Issue List

NCANG Repair Bldg 51 (Charlotte, NC)

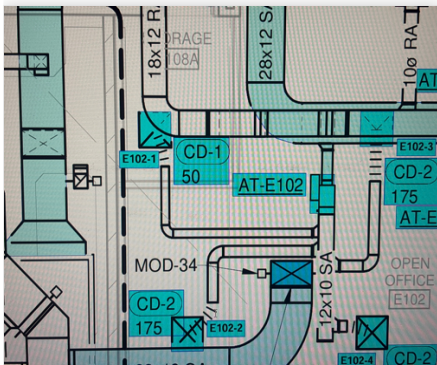
Issue Name : VAV AT-E102 Missing Diffuser
Description : Diffuser E102-1 is missing in room STORAGE 108A
Created By : National TAB **Assigned To :** National TAB - Antonio Flores-De La Cruz
Status : Closed
Priority : Urgent **Asset Tag :**
Originated Date : 01/21/2026 - Antonio Flores-De La Cruz - National TAB

- **02/09/2026 National TAB - Antonio Flores-De La Cruz**
 - Installed and DONE

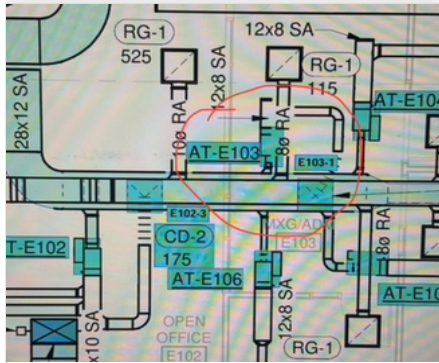
Issue Name : VAV AT-E103 Wrong Location
Description : VAV AT-E103 is installed in the wrong location per the drawings. It should have been installed in MXG/ADM E103 but instead was installed in room OPEN OFFICE E102. A diffuser is installed in room E103, but it is connected to VAV AT-E101, which is incorrect.

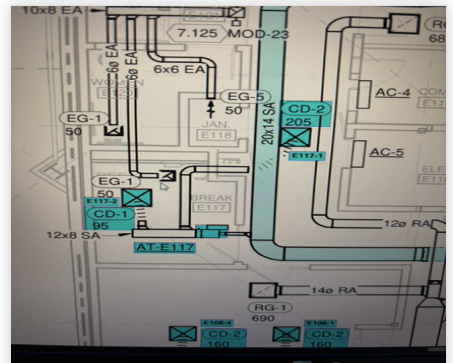
Issue Name : VAV AT-E117 Missing Grille
Description : Diffuser E117-1 in CORRIDOR E115 is missing. Upon inspection, it appears that the duct is attached to the VAV but it stops at the brick wall of room BREAK E117 and doesn't penetrate to the other side.
Created By : National TAB **Assigned To :** National TAB - Antonio Flores-De La Cruz
Status : Closed
Priority : Urgent **Asset Tag :**
Originated Date : 01/21/2026 - Antonio Flores-De La Cruz - National TAB

- **02/09/2026** **National TAB - Antonio Flores-De La Cruz**
 - done

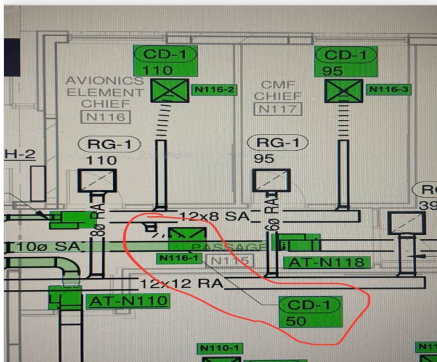
Issue Name : VAV AT-N116 Missing Diffuser
Description : Diffuser missing in Passage N115 (N116-1).
Created By : National TAB **Assigned To :** National TAB - Antonio Flores-De La Cruz
Status : Closed
Priority : Urgent **Asset Tag :**
Originated Date : 11/11/2025 - Antonio Flores-De La Cruz - National TAB

- **02/09/2026** National TAB - Antonio Flores-De La Cruz
 - done

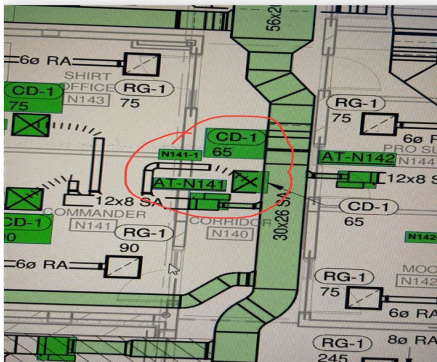
Issue Name : VAV AT-N141 Missing Diffuser
Description : Diffuser in Corridor N140 (N141-1) is missing.
Created By : National TAB **Assigned To :** National TAB - Antonio Flores-De La Cruz
Status : Closed
Priority : **Urgent** **Asset Tag :**
Originated Date : 11/11/2025 - Antonio Flores-De La Cruz - National TAB

- **02/09/2026 National TAB - Antonio Flores-De La Cruz**
 - done
- **01/21/2026 National TAB - Antonio Flores-De La Cruz**
 - SAW MECHANICAL CONTRACTOR FIXING ISSUE, WILL CHECK
- **11/12/2025 National TAB - Antonio Flores-De La Cruz**
 - Diffuser was installed, but after attempting to balance, the supply grille in Shirt Office N143 (N141-2) is swapped with the grille for the return. It must be swapped.
